SL	TABLE OF CONTENTS
1.	Table of contents
2.	Controller Power Supply
3.	Ethernet Power Supply
4.	CPSW Ethernet
5.	CPSW Ethernet Magnetics & Clocks
6.	AM2634 Conn Part 1
7.	AM2634 Conn Part 2 & RESET mech of both AM2634 & CPSW Ethernet
8.	AM2634 Conn Part 3
9.	Boot Selection

Title		
01. TABLE OF CONTENTS		
Size A	Document Number BLIS-Custom-Board	Rev V03
Date:	Monday, May 25, 2026	Sheet 1 of 10

REVISION HISTORY:- V02 TO V03

CPSW Ethernet

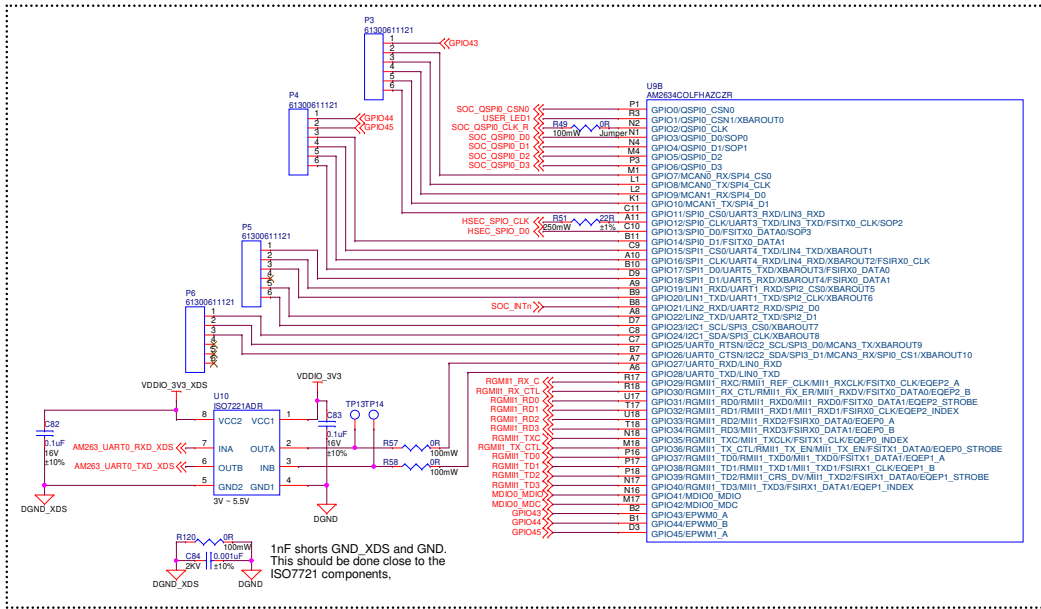
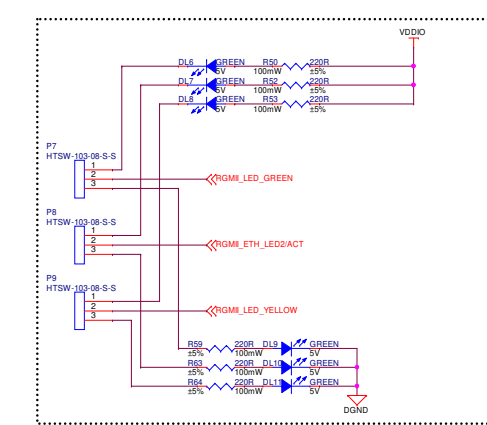
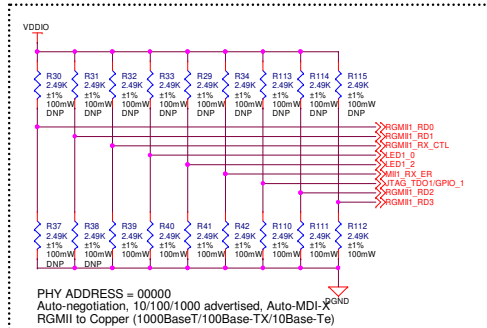
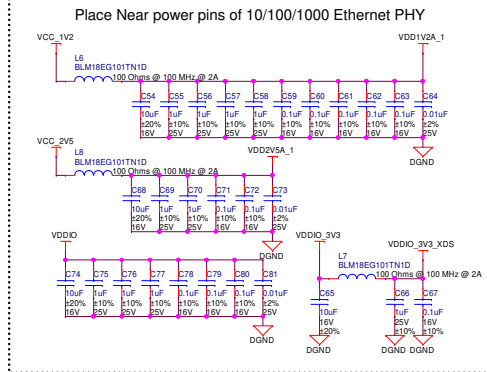
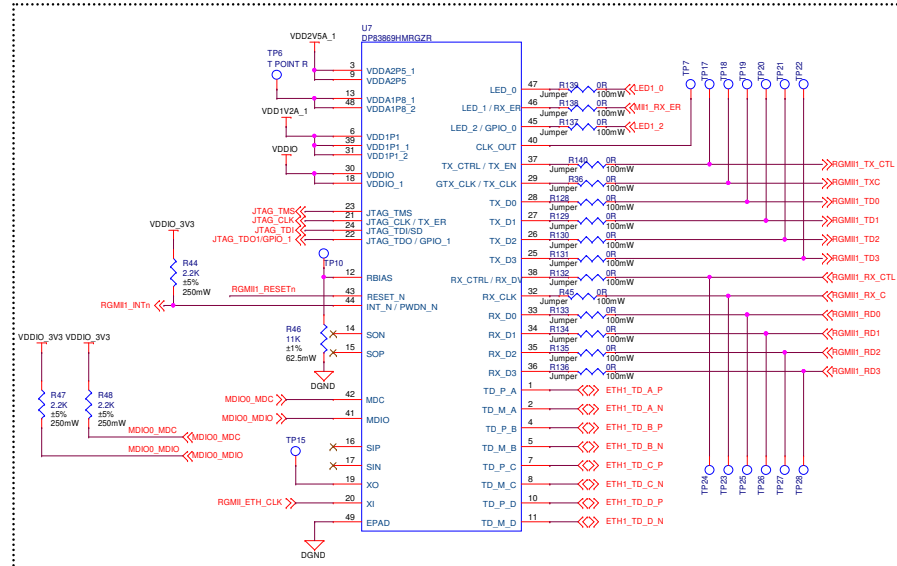
1nF shorts GND_XDS and GND. This should be done close to the ISO7721 components.
